UNC Charlotte Phase 16

Addendum #4

Revision Narrative

2021-09-08

E-205S-A

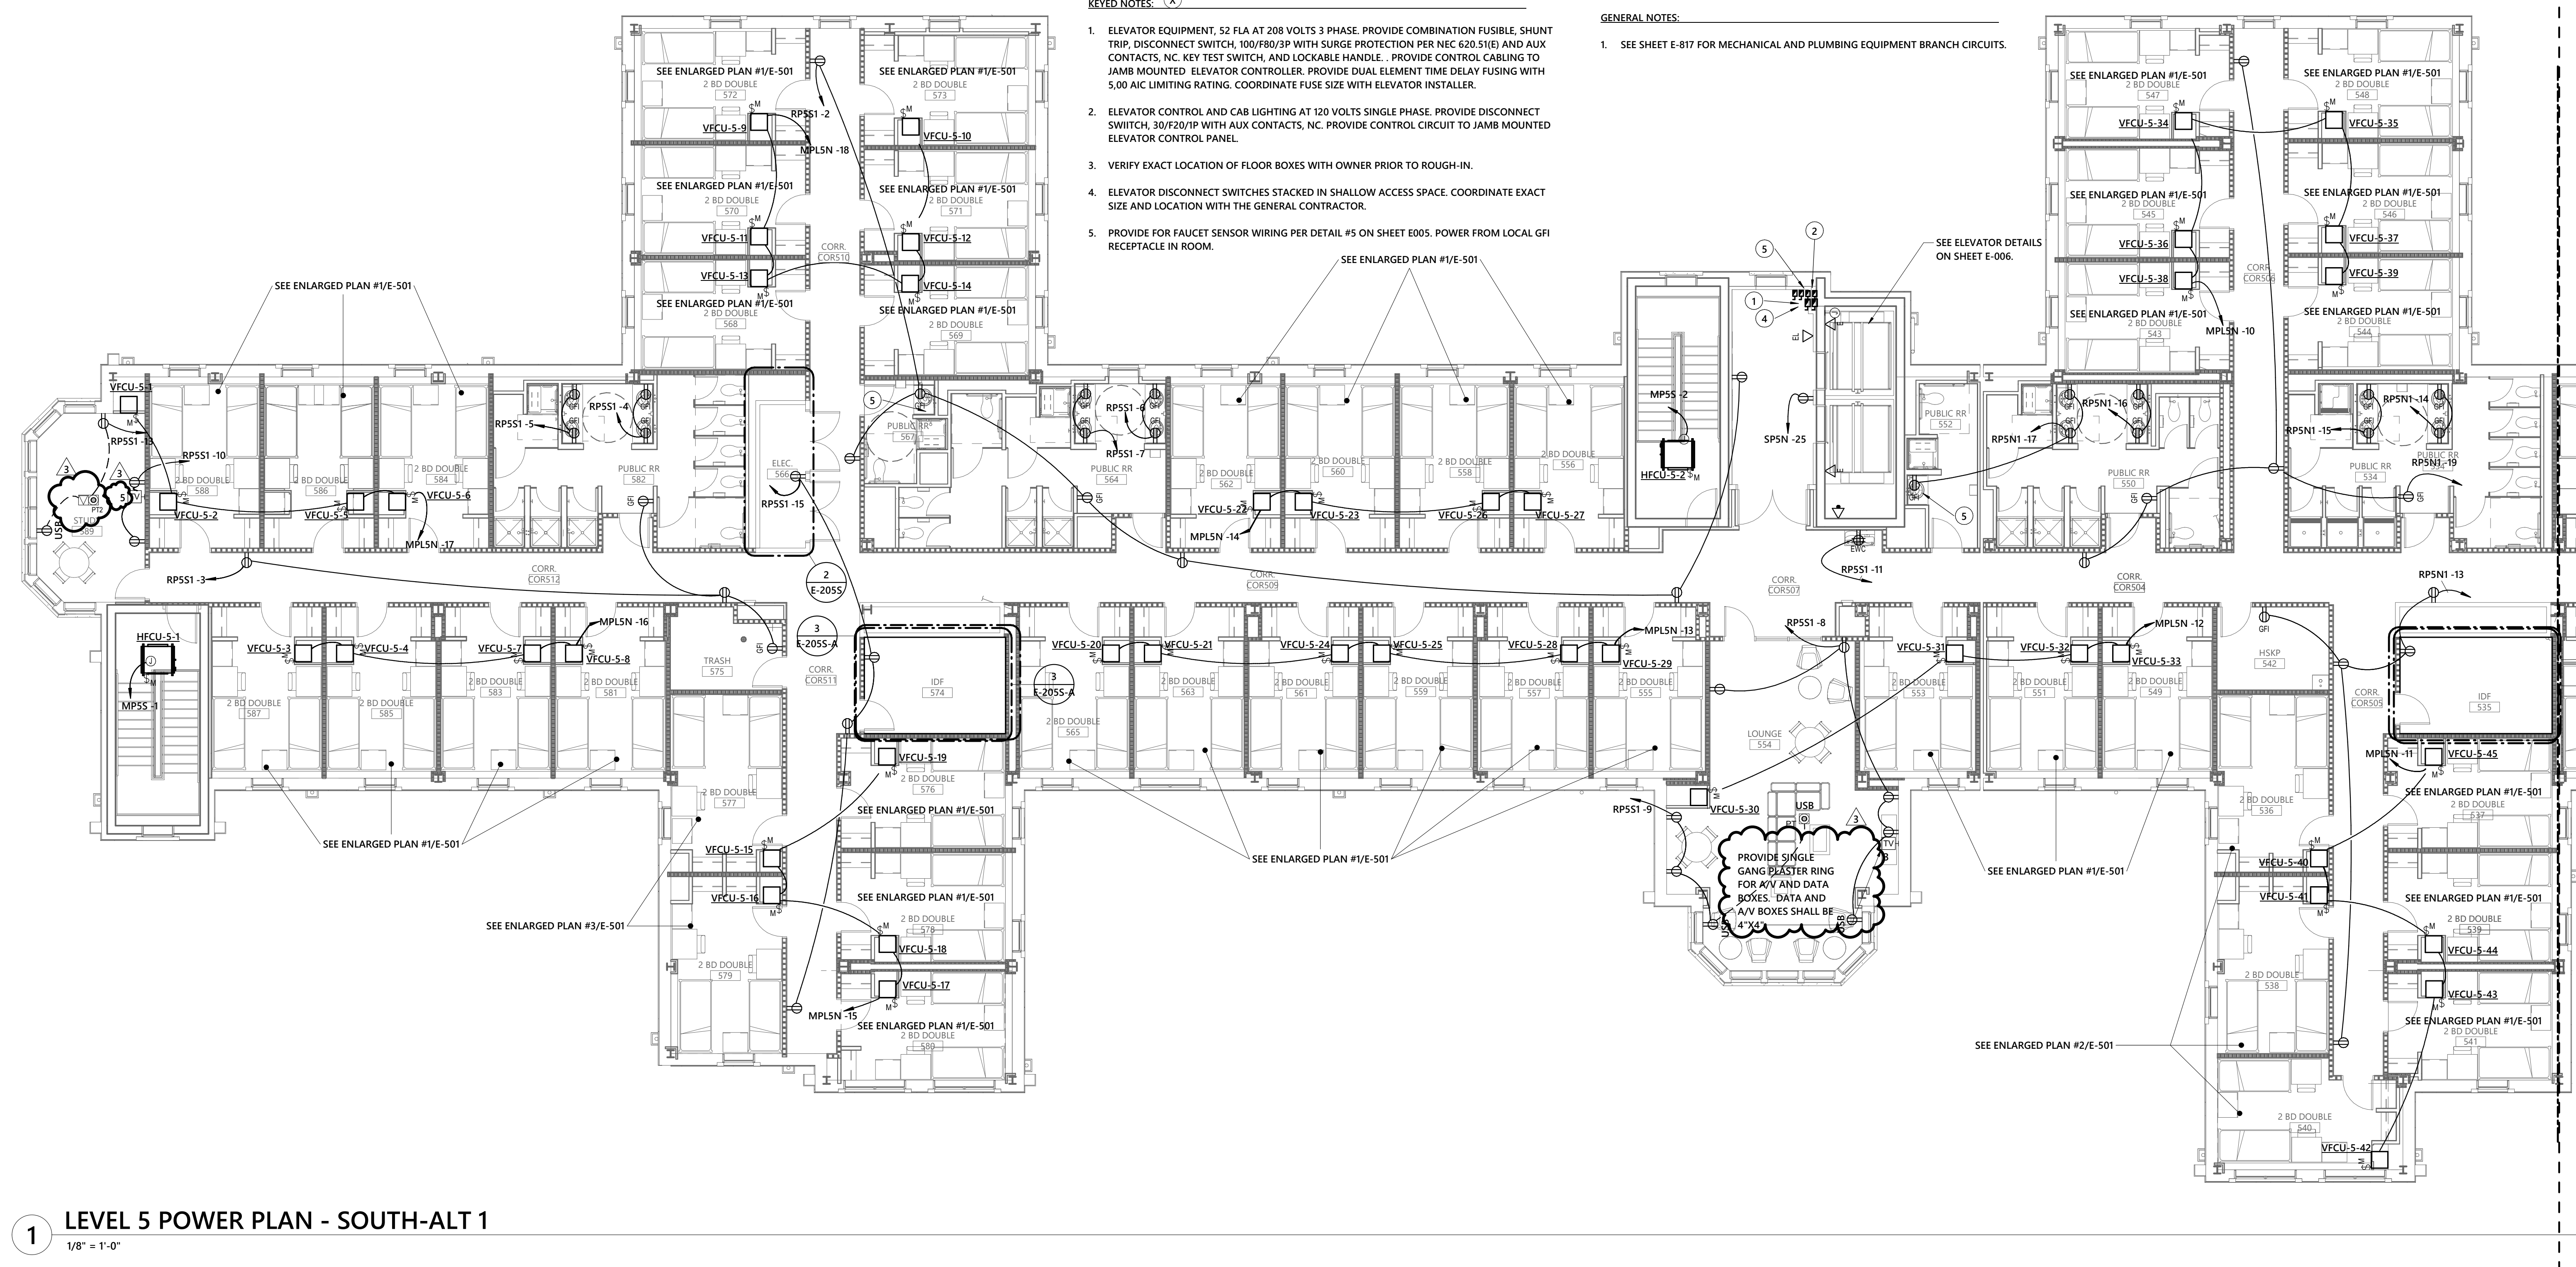
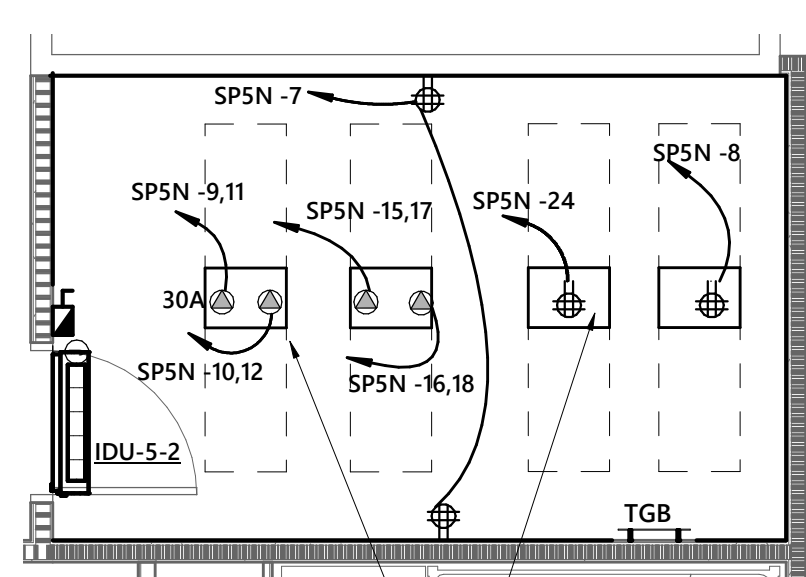
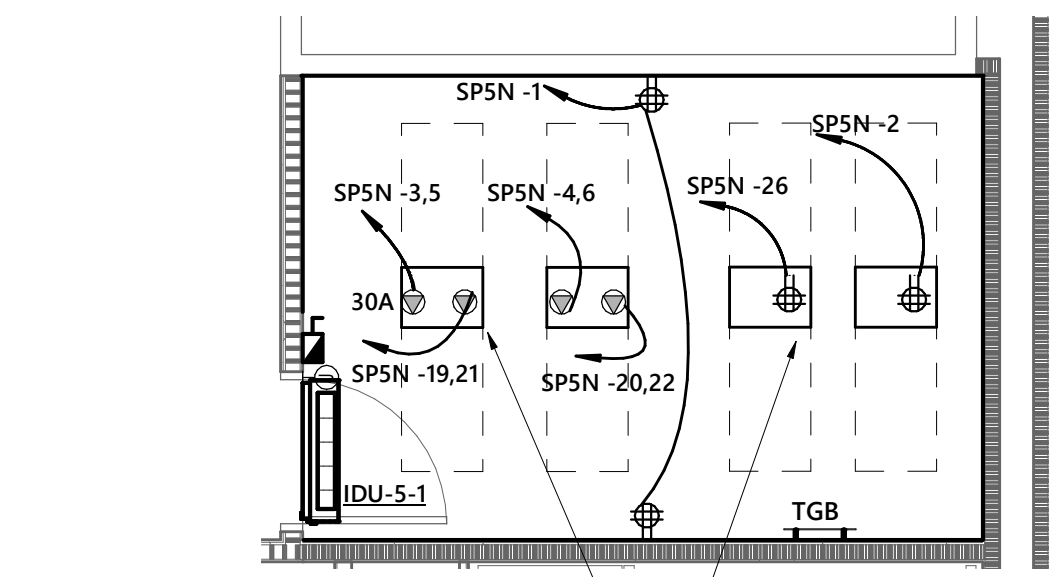
E-205S-A - Changed TV type. Added note for opening type of junction box. Poke thru type changed.

E-400S

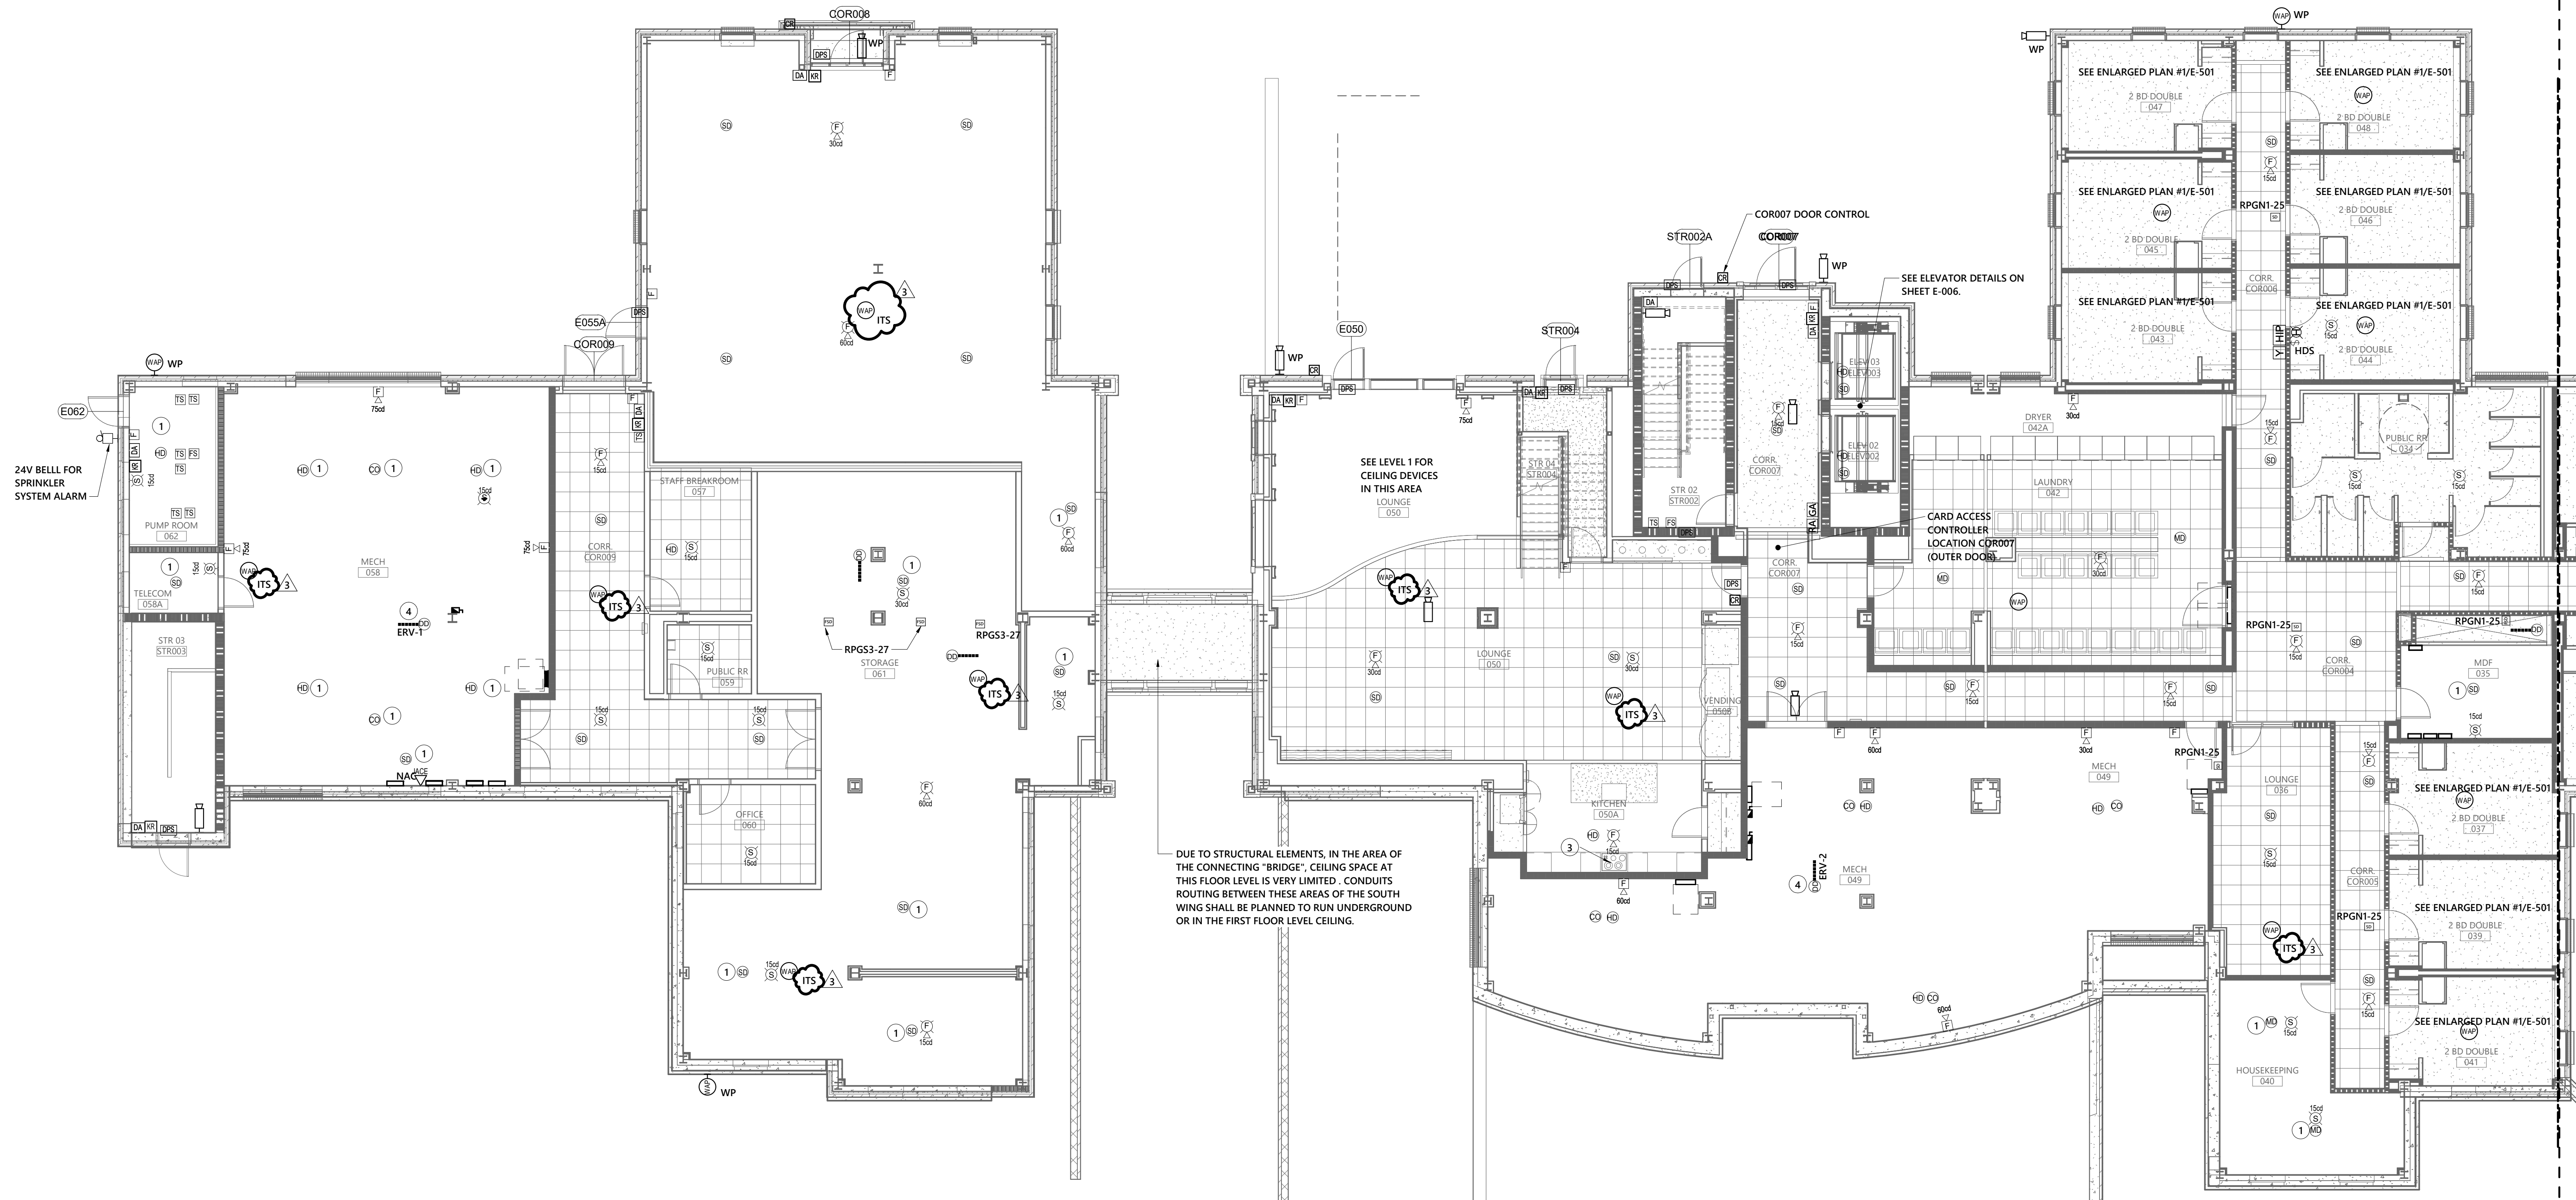
E-400S - WAP added. ITS designations added.

E-400S-A

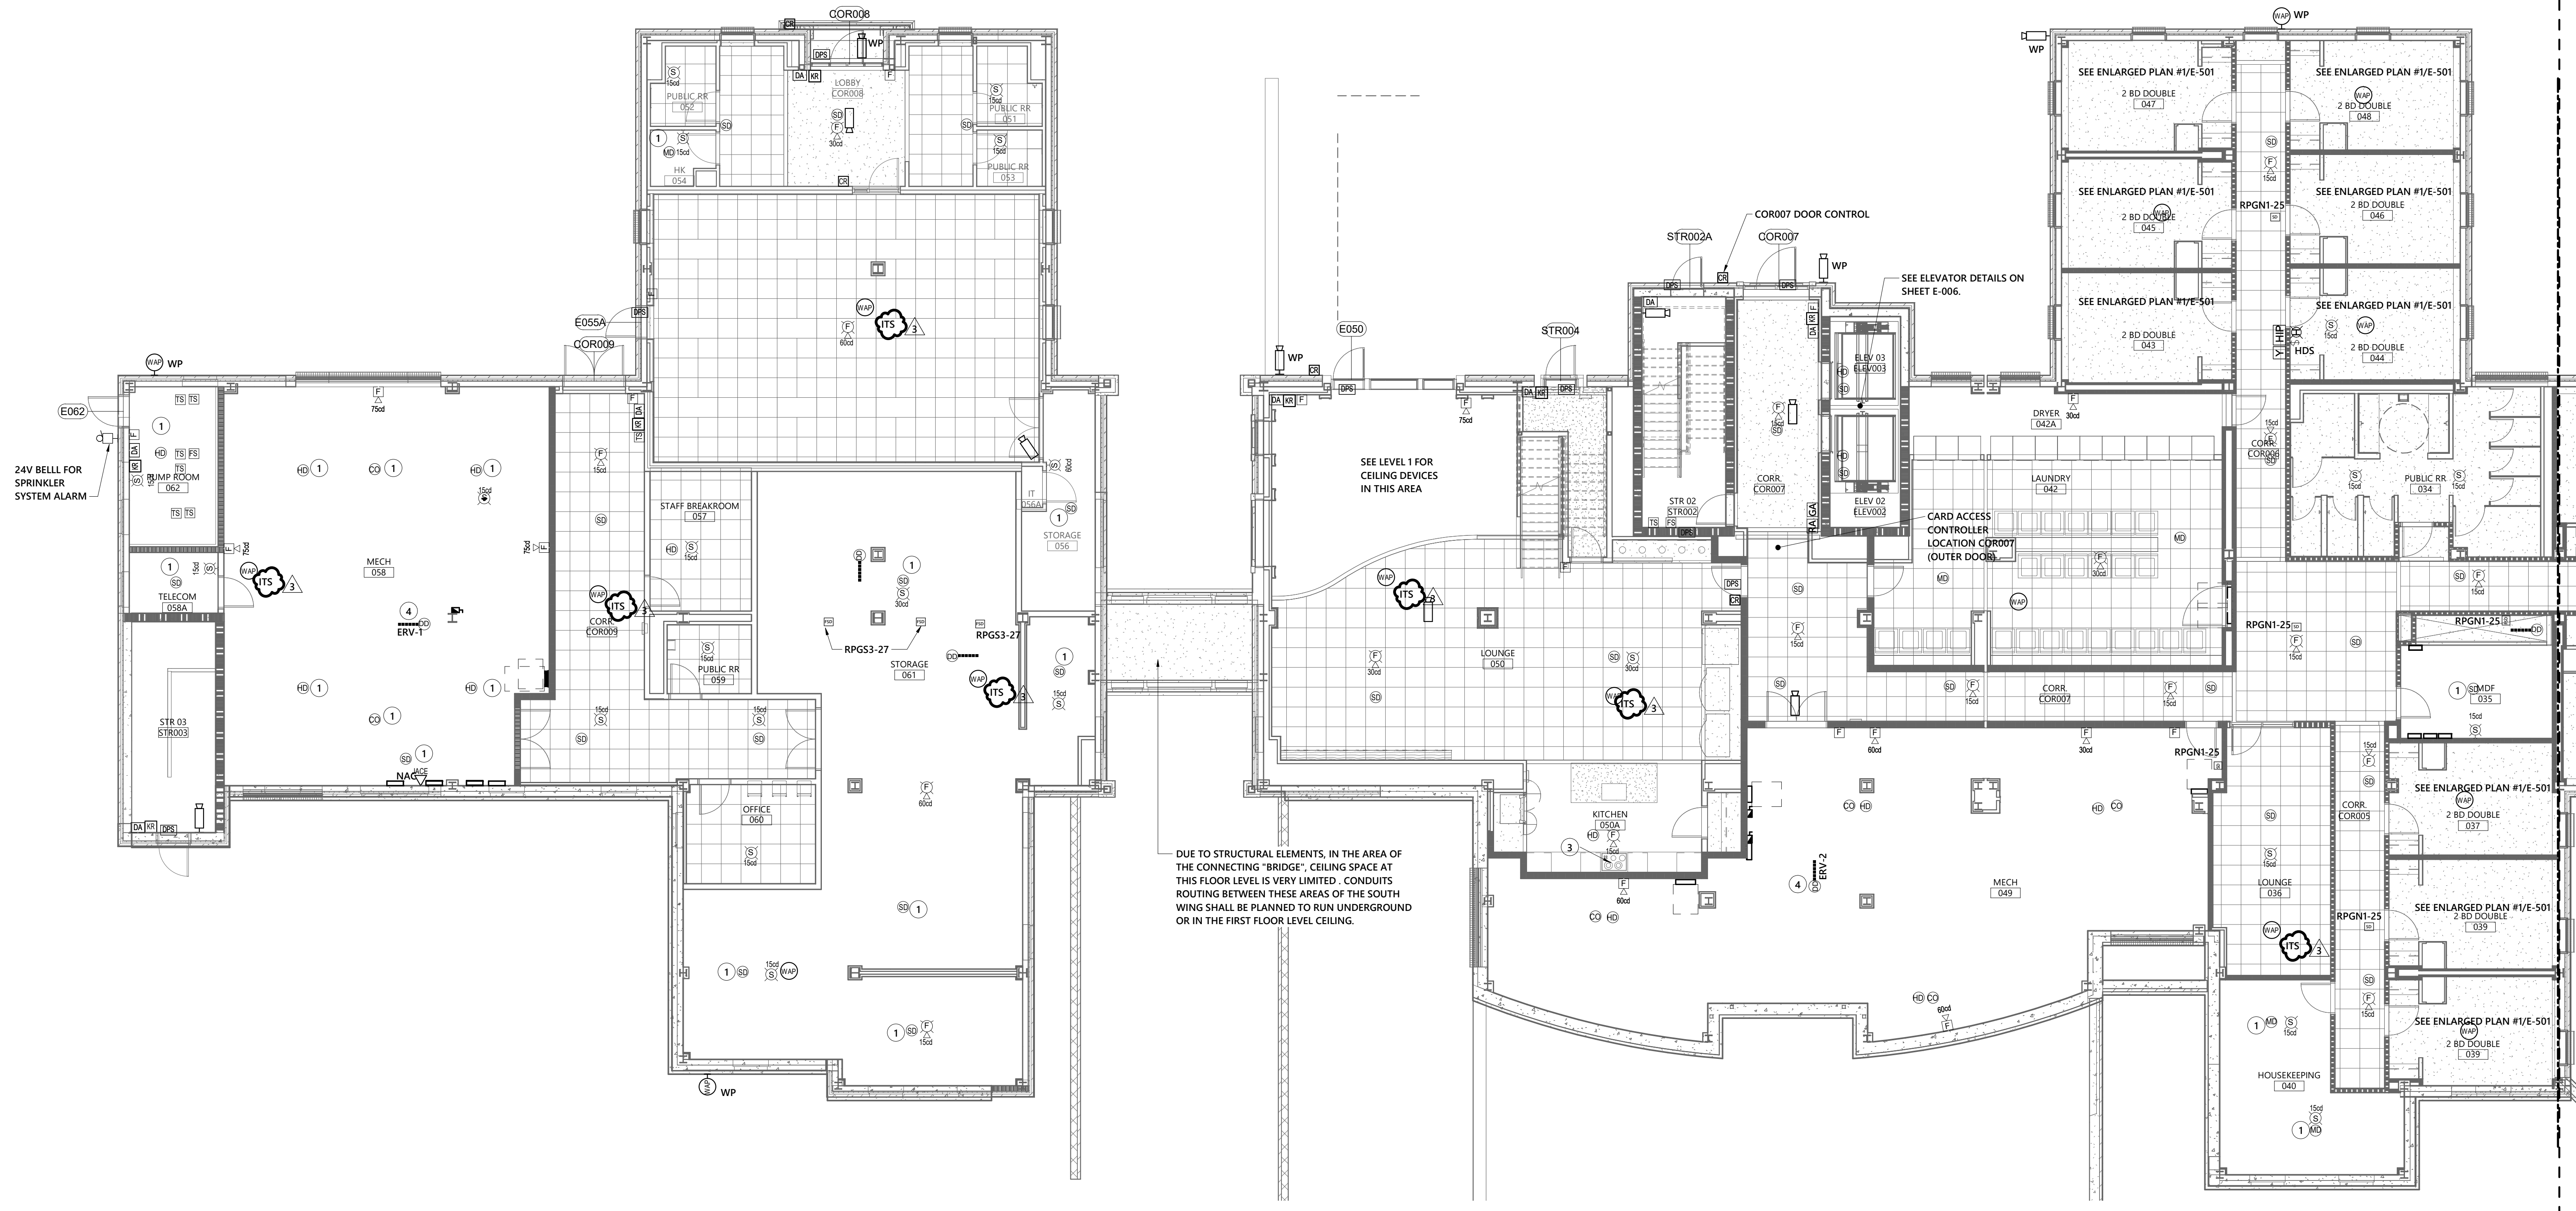
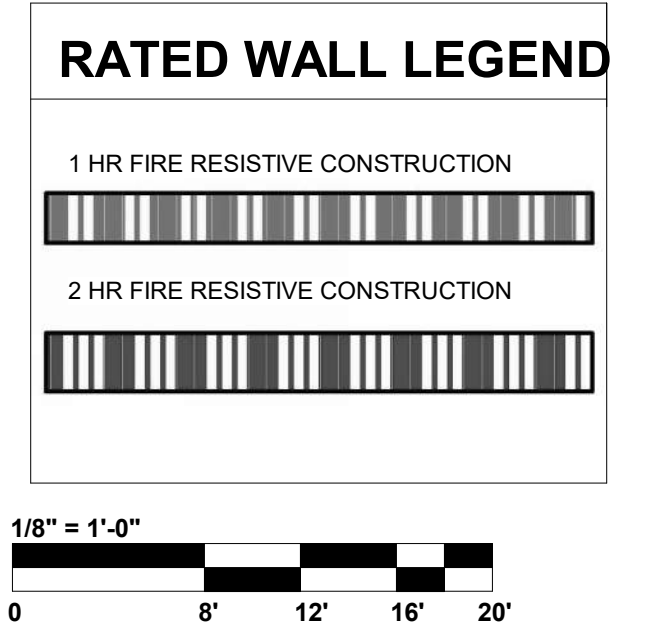
E-400S-A - ITS designations added.
